UNITED STATES PATENT AND TRADEMARK OFFICE

APPLICATION NO.	FILING DATE	FIRST NAMED INVENTOR	ATTORNEY DOCKET NO.	CONFIRMATION NO.
10/630,583	07/29/2003	Kristopher J. Frutschy	042390P16902	1628

Office Action Summary	Application No.	Applicant(s)	
	10/630,583	FRUTSCHY, KRISTOPHER J.	
	Examiner	Art Unit	
	Thanh-Tam T. Le	2839

DETAILED ACTION

FIGURE A

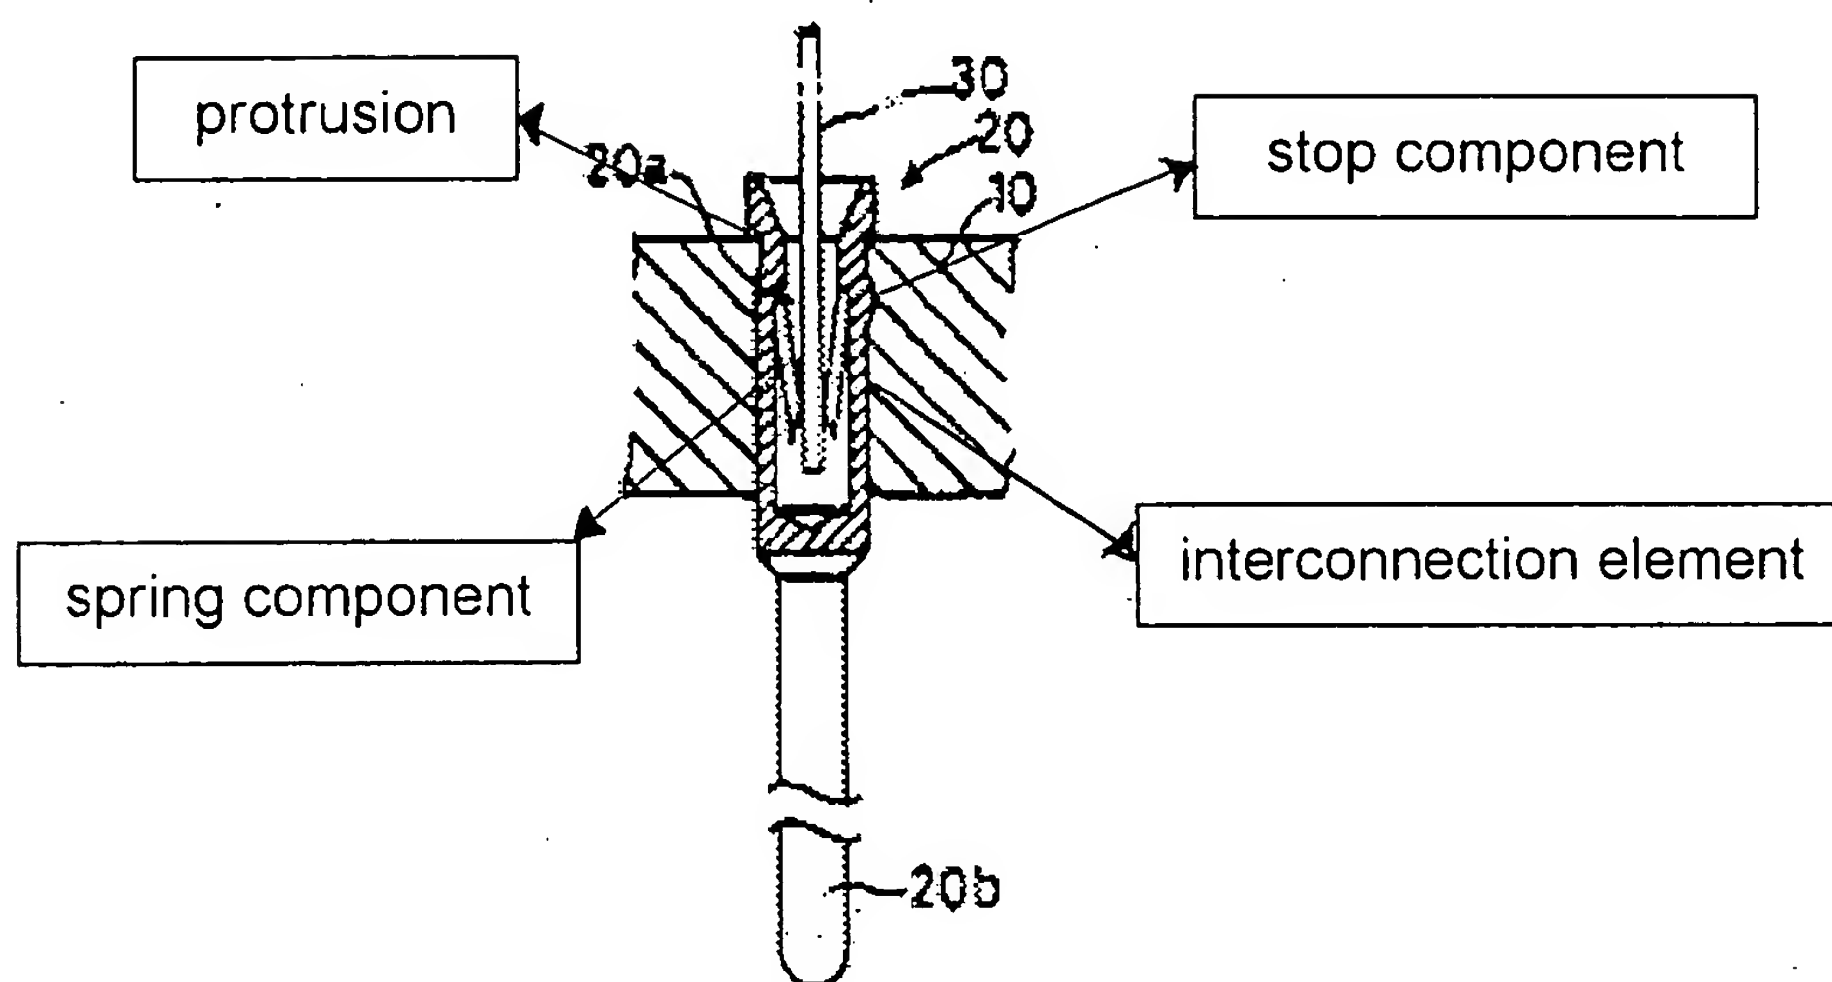
Regarding claims 1 and 10, Arisaka, figures 2-3 and a figure A (noted by an Examiner), discloses a socket for a microelectronic component, comprising:

- a socket body (10) having a formation for receiving the microelectronic component and including at least a first metal portion (14);
- a plurality of contacts (top side of socket pins 20-23) on the socket body;
- a plurality of terminals (20b) on the socket body;
- a plurality of interconnection elements (see a figure A below) in the socket body, each interconnecting a respective contact with a respective terminal; and
- a protrusion (the figure A below) on each interconnection element, a respective interconnection element and a respective protrusion being inserted into an opening in the socket body until the protrusion is in contact with the first metal portion, at least a first set of the interconnection elements all being

electrically connected through the respective protrusions thereon to the first metal portion.

Regarding claim 3, a stop component (the figure A below) on the interconnection element to limit how far the interconnection element is inserted into the opening and to ensure that the protrusion is in line with the metal portion.

Regarding claim 8, a plurality of spring components (the figure A below) on the interconnection element, each contact being on a respective spring component.
